26-008 DT12 Oil Plug Ports

TSB-26-008-WST

Creation Date: 2025-04-30

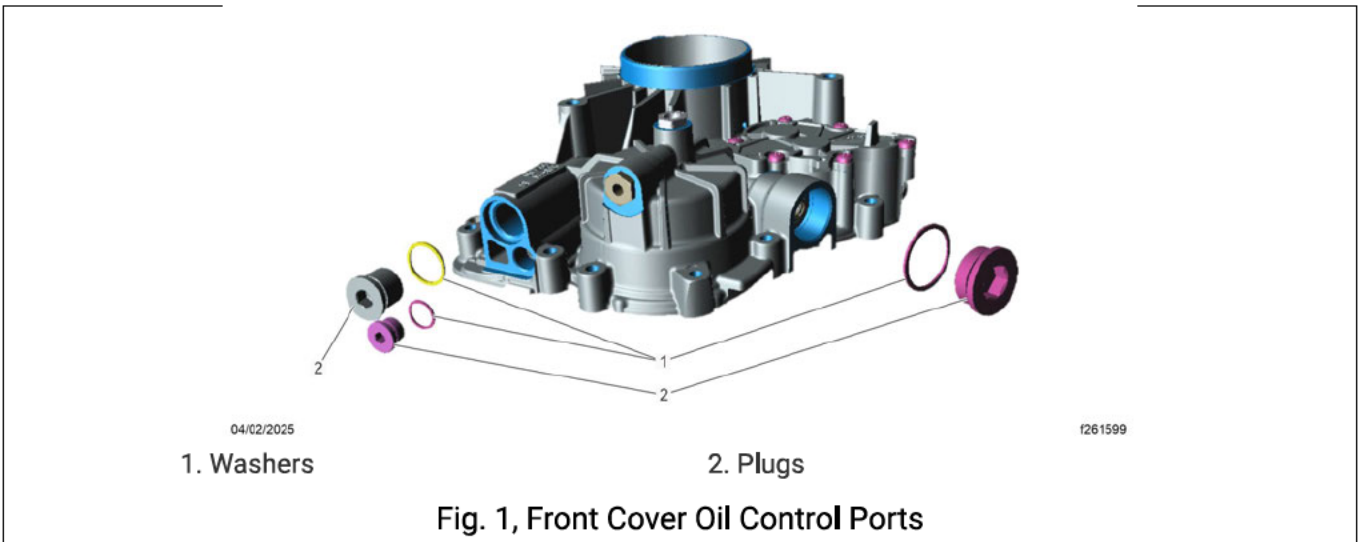
Starting in 2024, new production DT12 C/D-box transmissions have an updated sealing solution for the oil control port plugs on the front cover. The old solution used plugs with crush washers, as shown in Fig. 1. The new solution uses different plugs with pre-applied, or field-applied sealant. The update will happen for each port plug at different times. Depending on the build date, it is expected to find transmissions with one, two, and eventually all three updated plugs.

The new plugs with sealant have different dimensions and are not compatible with the crush washers. The additional thickness of the crush washer changes the position of the thermal and pressure springs used to control the valves.

During the service on these plugs, use seal rings for the plugs designed to have them, or use the newer plugs with the pre-applied sealant. The seal rings must never be added to the plugs that are designed to be used without them.
